ICHD - ENVIRONMENTAL HEALTH DIVISION

PERMIT # OSWP-2022-7381

SEPTIC: IMPROVEMENT PERMIT / AUTHORIZATION TO CONSTRUCT / OPERATION PERMIT / EXISTING SYSTEM

Comments / Conditions: Purpose of this permit is to approve the area for a swimming pool. Current pool plan will not impact septic drain field or tanks.

INITIAL SITE SKETCH

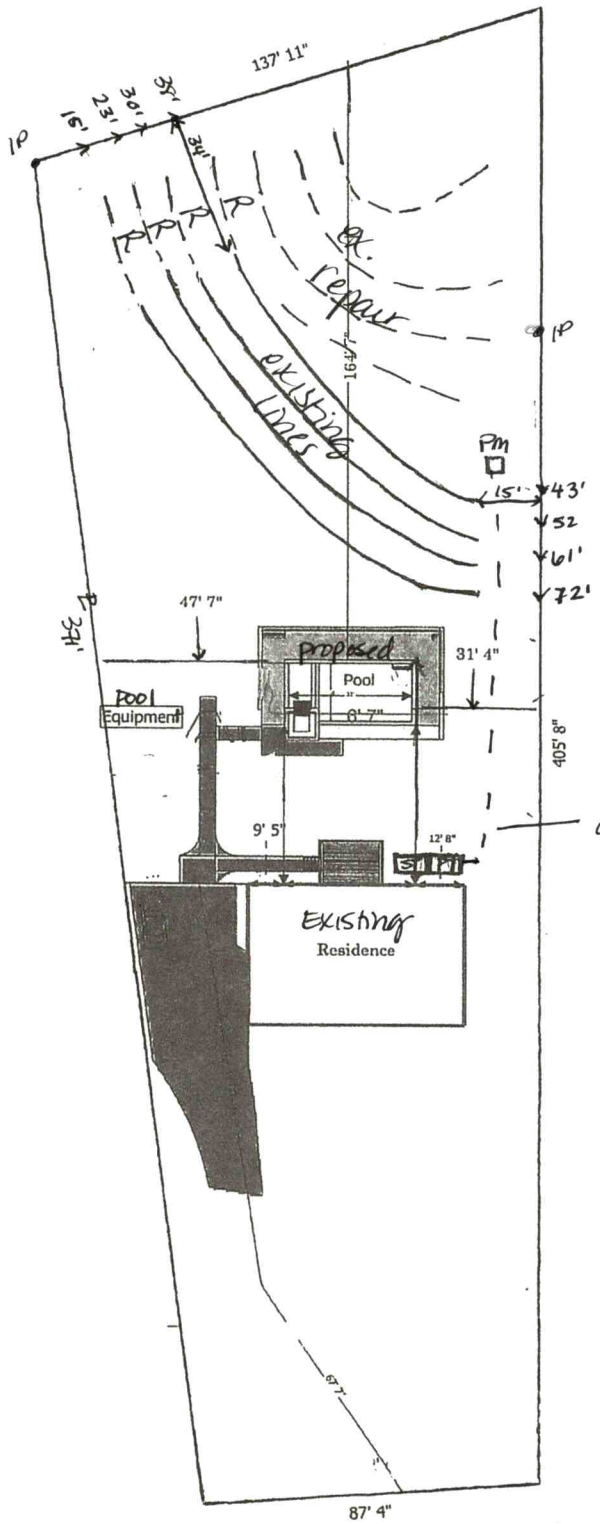
Pool as staked is 15' or greater at all points from septic components.

See attached Site plan by ICHD & pool designer

apparent location of supply line. (traced)
If line is within construction area, call Env. Health immediately, relocate to 10' off pool
